Open Letter

Life Cycle Associates and several individuals knowledgeable of the LCFS are writing to provide comments on the draft document "Detailed California-Modified GREET pathway for Corn Oil Biodiesel (COB)," which was posted on the ARB Low Carbon Fuel Standard (LCFS) website on Dec. 14<sup>th</sup>, 2010.

**Figure 2.** System Boundary Diagram for Corn Ethanol Mill Producing Incremental COB.

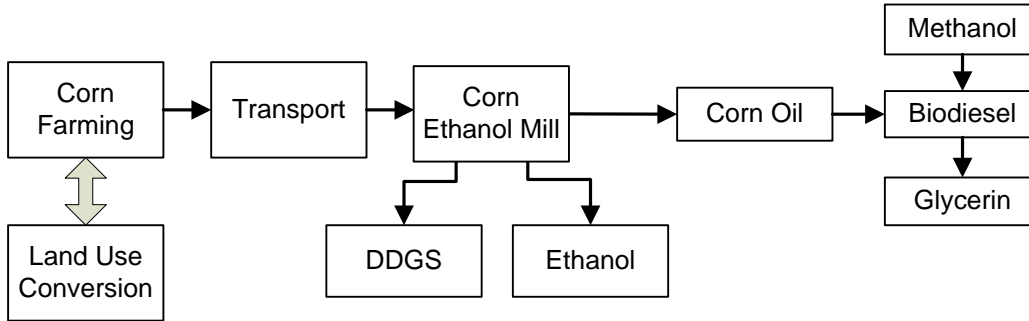
ARB treats corn oil extraction as an incremental technology. This approach assigns the electrical energy for corn oil extraction to the corn oil and provides a credit to the biodiesel for energy

savings realized by integrating oil extraction into the fuel plant. The advantage in this approach is that it partially assigns the energy inputs based on the processing energy. However, the ARB's approach selectively defines COB as an incremental technology. The system boundary diagram for this approach is shown in Figure 2. ARB's treatment of the incremental biodiesel production is inappropriate because corn ethanol is also a fuel under the LCFS. The calculations for this approach are also reviewed in Section 3.
